Addendum #1

PROJECT:	ADDENDUM NO.	001
IVH Sheeler – Loftus Remodel		
Iowa Veterans Home	DATE ISSUED:	11/15/2017
1301 Summit Street, Marshalltown, IA 50158	BIDS DUE:	11/30/2017 (Revised Date)
DAS # 8950.00

TSP PROJECT NUMBER: 06-170221.00

ASI #1 - BRICK REPAIR - LINTEL

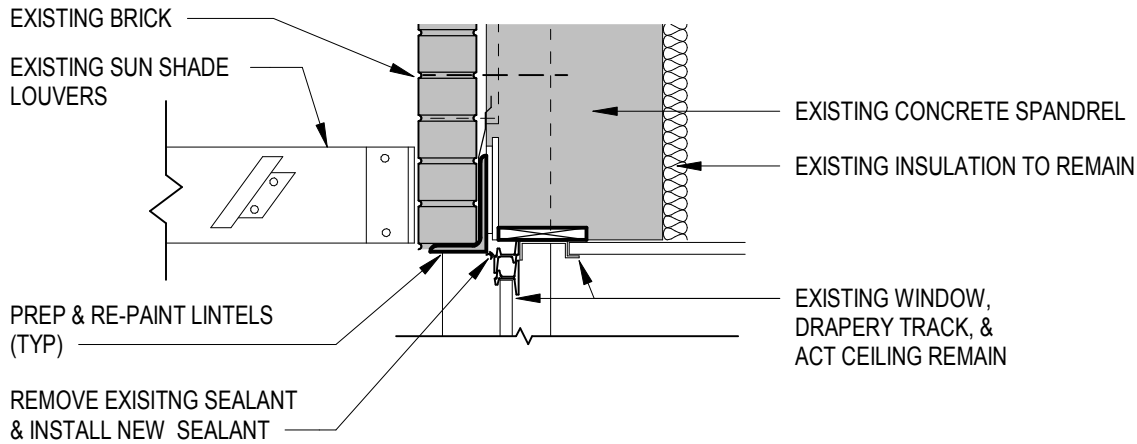
ITEM NO. 6: Steel Angle Brick Lintels – Scope of Work Clarification

- a. **Reference:** Sections 00 31 19 – Existing Conditions, 00 31 19.10 – Existing Conditions Photographs, 01 12 00 – Contract Summary, 04 01 20 – Brick Masonry Repair, Section 09 91 13 – Exterior Painting, Drawings Sheet A-201 – Building Elevations, Supplemental Drawing ASI 01 – Steel Angle Brick Lintel as attached.
- b. **Description:** As part of the Masonry Repair work the steel angle brick ledges at window and other openings shall be cleaned, prepped and re-painted. See Supplemental Drawing ASI 01 – Steel Angle Brick Lintel as attached.

ASI #2 - BRICK REPAIR - COLUMN JOINT

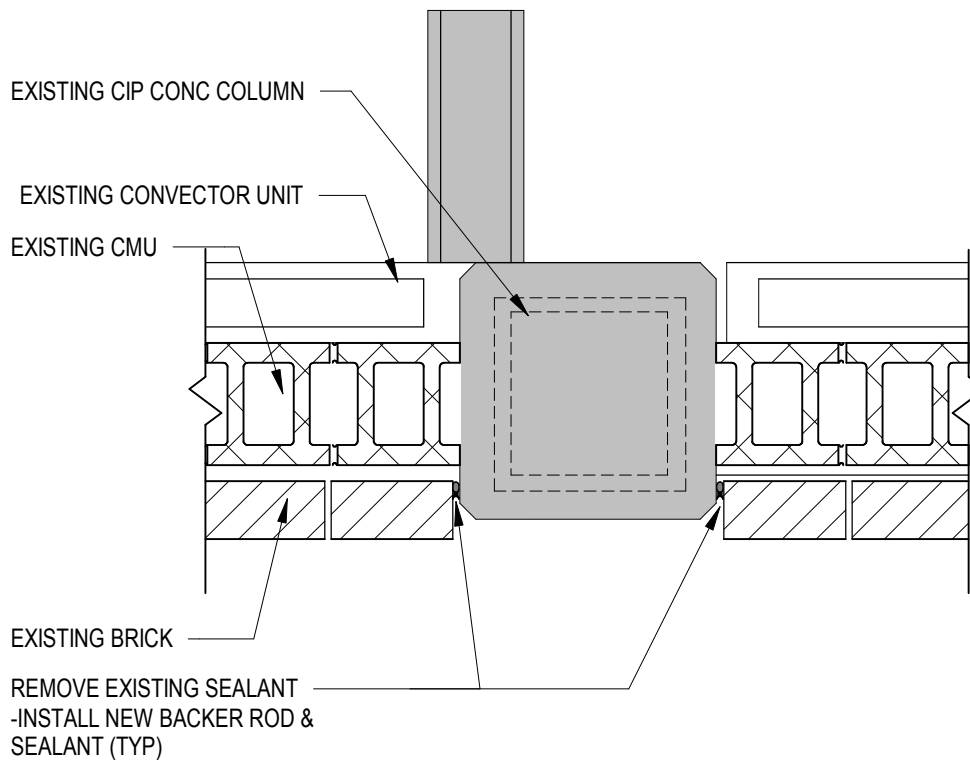
ITEM NO. 7: Caulking at CIP Concrete Columns – Scope of Work Clarification

- a. **Reference:** Sections 00 31 19 – Existing Conditions, 00 31 19.10 – Existing Conditions Photographs, 01 12 00 – Contract Summary, 04 01 20 – Brick Masonry Repair, Section 07 92 00 – Joint Sealants, Drawings Sheet A-201 – Building Elevations, Supplemental Drawing ASI 02 – Brick / Column Plan Detail (Sealant Locations) as attached.
- b. **Description:** Upon completion of masonry cleaning, masonry repair and tuckpointing, the vertical joint between brick panels and CIP Concrete Columns shall be cleaned raked and caulked per Section 07 92 00. Existing vertical masonry control and expansion joints, including the one shown on the north elevation, shall be cleaned raked and caulked per Section 07 92 00. Sealants to match cleaned and cured masonry mortar.
